Subject: Borel Middle School HVAC Replacement
San Mateo - Foster City School District
Aedis Project No. 2021005
DSA Application #01-119557

ADDENDUM NO. 1

ELECTRICAL NEW PARTIAL FLOOR PLAN - BLDG G

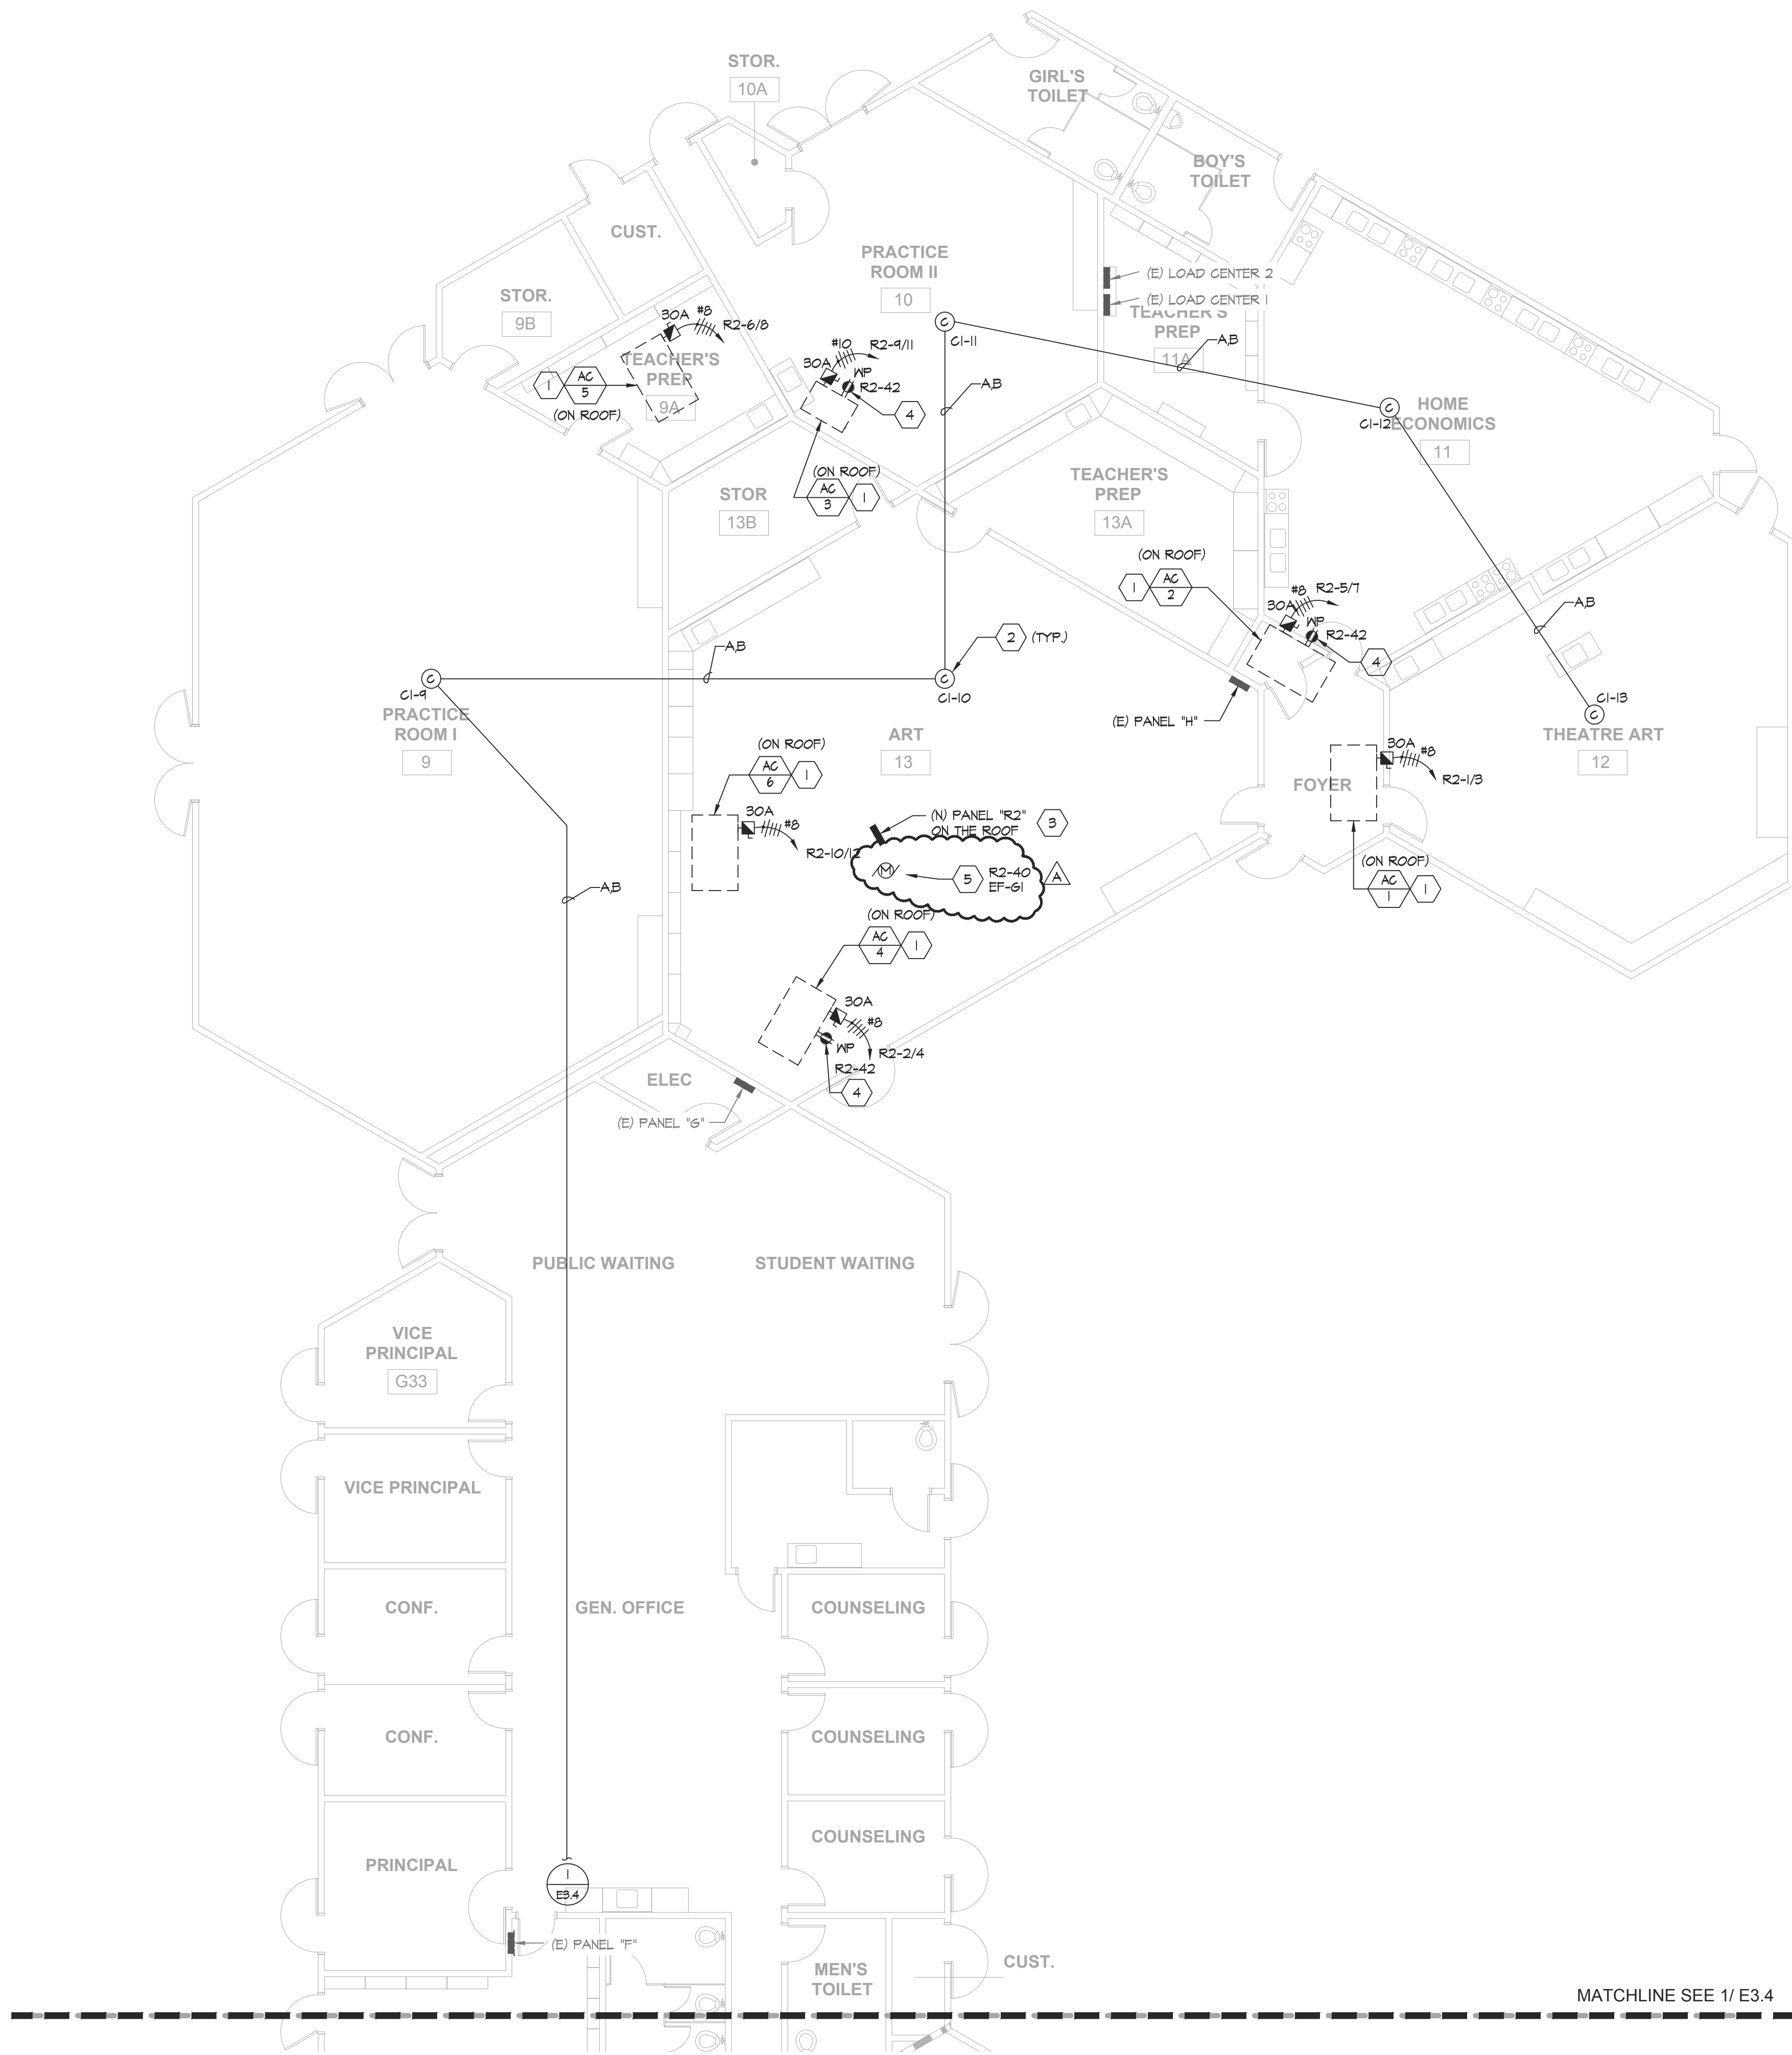
Add: Power for Exhaust Fans at building per AD1-E3.3

Add: General Note #9 per AD1-E3.3

Add: Sheet Note #5 per AD1-E3.3
